**REVISED SUBMISSION**

**Re: 300 Rella Boulevard, Montebello, NY - Site Plan/Special Permit**  
**Acoustical Review of Proposed Warehouse Application Comments**

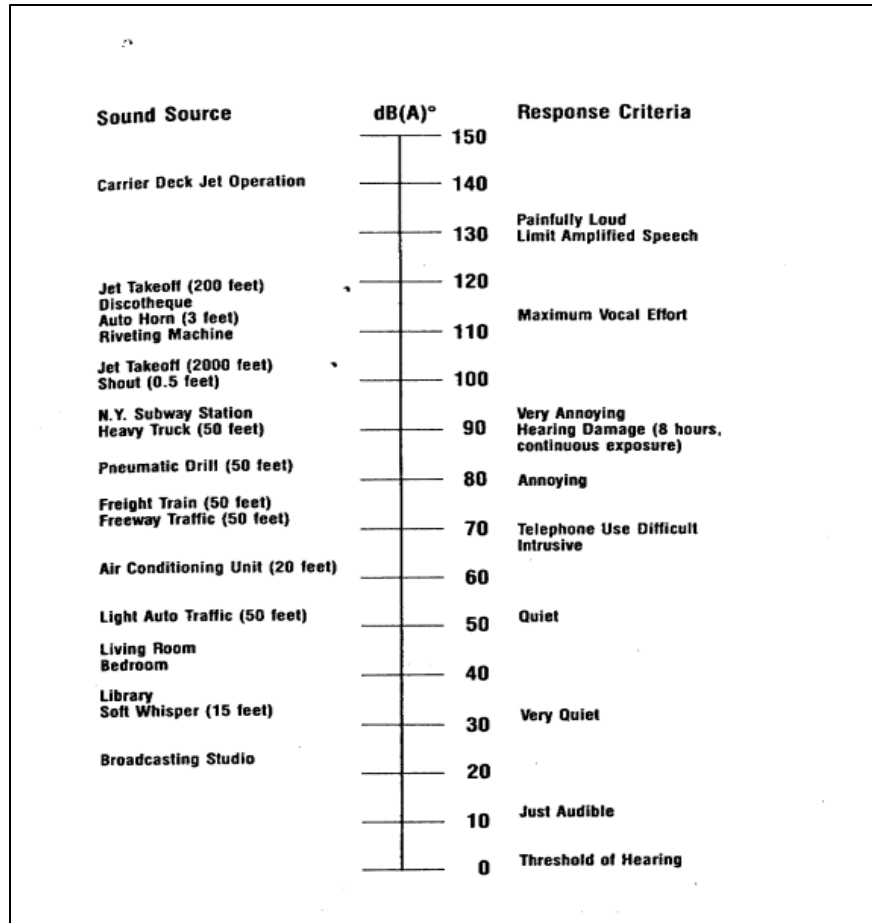
Comment 7: LSG&A requests that a revised results Table 2 be provided with all six noise sensitive receivers with the additional equipment, backup alarms, loading activities and truck movements added to the results.

To anticipate for potential, additional sources, and modifications of the site plan, the noise modelling was updated. Sources incorporated into the model are provided in Comment 4 above. The results depict that operational levels at the Residential receivers would be more consistent with residential sound levels than a commercial facility. Levels will range from 49.2 to 54.6 decibels during the daytime hours and 46 to 48.7 decibels during nighttime hours. Commercial limits are typically 65 dB(A) during daytime hours and 50 dB(A) during nighttime hours. The commercial receptor to the north would have a sound level typical of a commercial facility fronting a commercial facility. Levels would drop significantly during the evening hours, 56.3 dB(A), as the northern roadway would be only utilized by smaller 2-axle trucks only. Guidance shows that sound levels in the 50-decibel range are considered quiet and not unreasonable as described in Chapter 118 of the Village Code. Further, these levels are for receptors outside. Per NYSDEC's Assessing and Mitigating Noise Impacts, "building walls and windows that are closed provide a 15 dB reduction in noise levels. Building walls with the windows open allow for only a 5 dB reduction in SPL."

\*Source: NYSDEC Assessing and Mitigating Noise Impacts. The information provided in the figure is not to be utilized as evaluation criteria rather it is only for comparative and comprehension purposes.

Figure 1 – Measurement Location Map

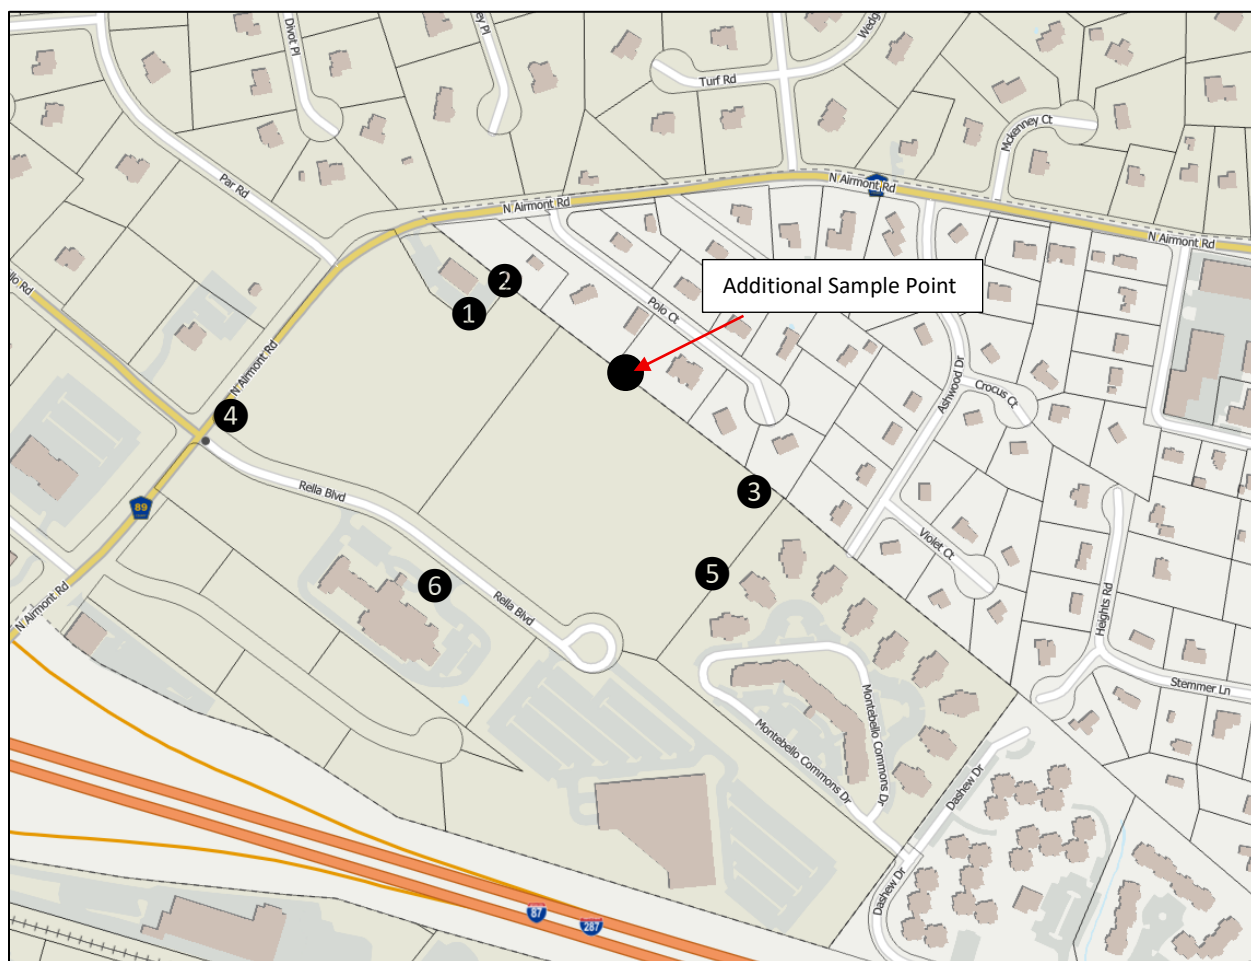
Comment 1: LSG&A is requesting a table summarizing; the baseline measurement locations, land use category, date and time of the measurements, duration of the measurements and the A-weighted (dB(A)) statistical  $L_{10}$ ,  $L_{90}$  and equivalent,  $L_{eq}$ , sound level results of the measurements at each Noise Sensitive Receiver.

Please see an updated measurement summary table at the end of this correspondence. Measurements expand several years as B. Laing Associates, Inc. initially conducted noise measurements for the site when it was a proposed lumber yard in 2020/2021.

FIGURE 2  
NOISETOOL RESULTS – DAYTIME HOURS

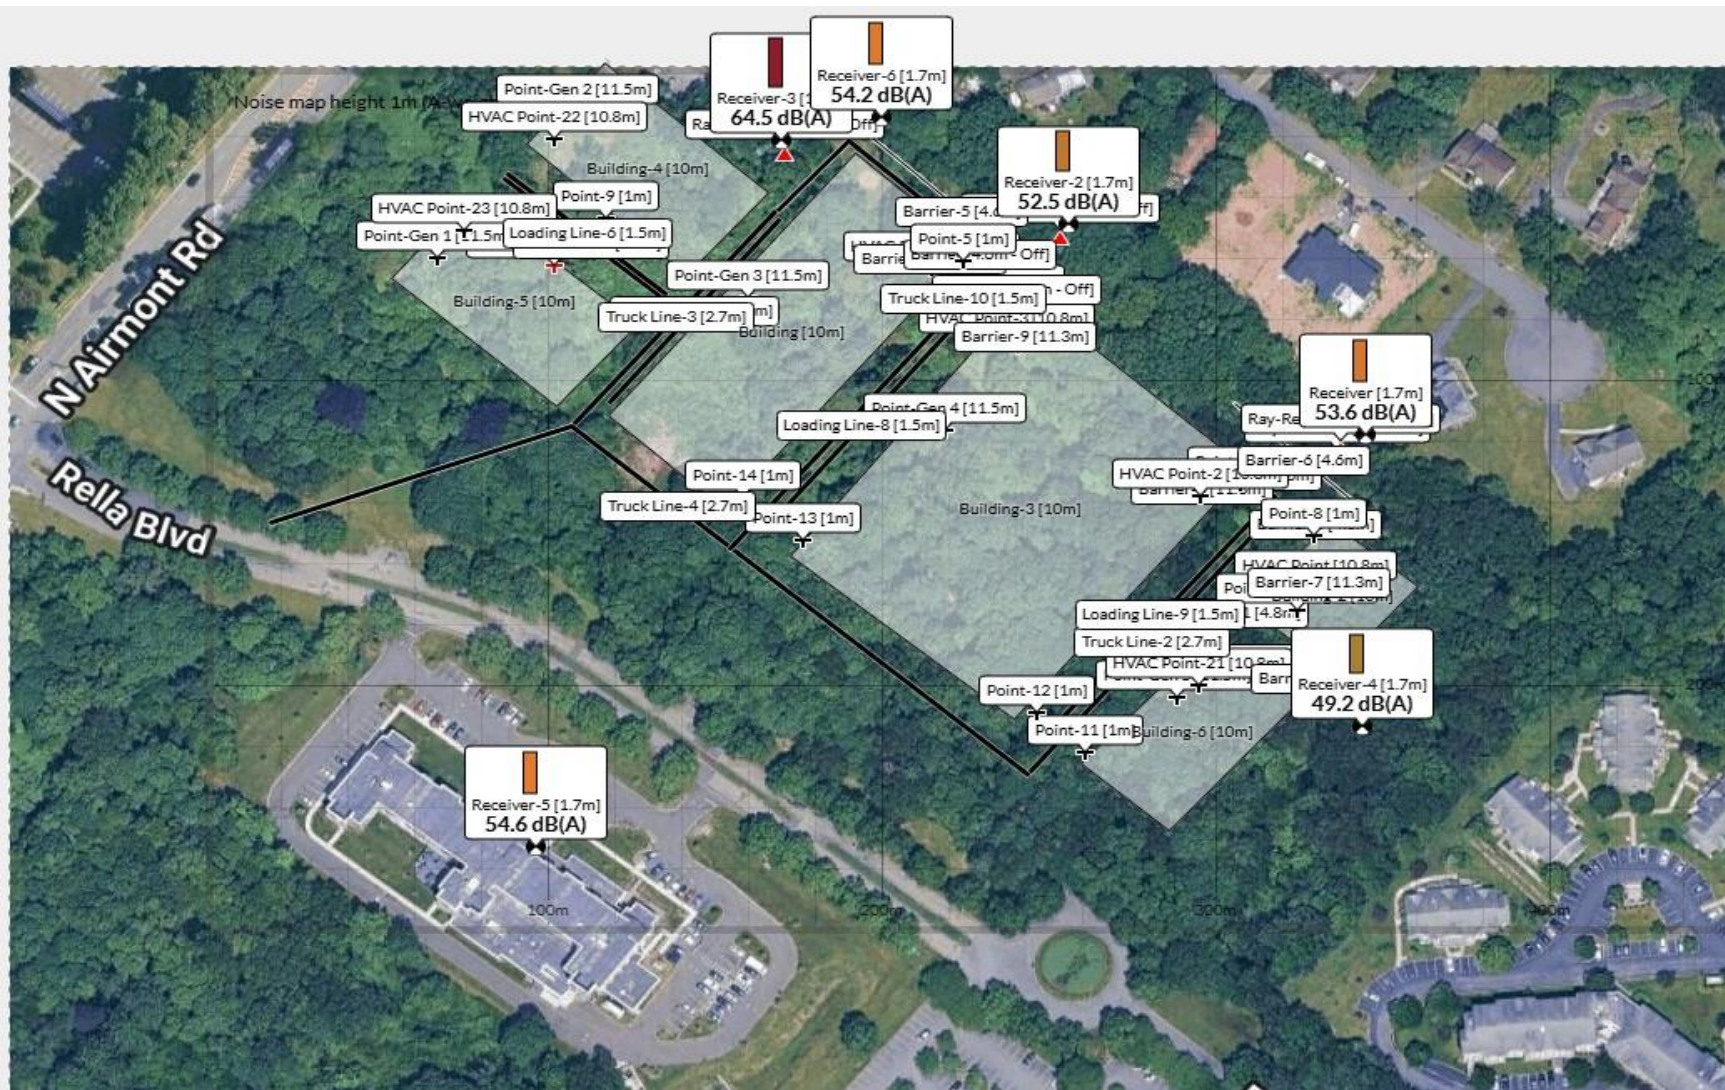
Comment 4: LSG&A is requesting the source overall sound power levels for all of the equipment included in the operational noise modelling.

Comment 6: LSG&A is requesting clarification on if backup alarms (beepers) and loading activities were included in the noise modelling. If they were not, LSG&A recommends that those activities be included in a revised noise model.

Sources of noise have been updated to reflect the comments provided by LSG&A.

- Points 1-4 and 21-23 represent rooftop HVAC equipment. The Sound Power Level used for these points was 84 dB/80.8 dB(A).
- Points 5 through 14 on the modelling reflect back-up alarms. The Sound Power Level utilized for these points was 95 dB/91.8 dB(A).

- A line source was added to the modelling to represent vehicular travel. The Sound Power Level for the line sources were input as 111 dB/107 dB(A) for daytime truck movements and 102 dB/98.8 dB(A) for nighttime movements. There are six (6) to eight (8) line sources, depending on time of day, in the model that represent truck movement and include reefer units.

- A line source was added to the modelling to represent loading activities. The Sound Power Level for the line sources were input as 102.2 dB/99 dB(A). These line sources were placed between Buildings 1 and 2, between Buildings 1 & 2 and 3, Buildings 3 and 4 and Buildings 4 and 5 & 6. There are four (4) line sources in the model that represent loading activities (i.e. fork lifts).

- Points Gen 1 through 6 represent rooftop generator equipment. The Sound Power Level used for these points was 102 dB/98.8 dB(A).

Point Sources 5 through 14 in the modelling reflect back-up alarms. The Sound Power Level utilized for these points was 95 dB/91.8 dB(A). A line source has been added to the modelling to represent loading activities.
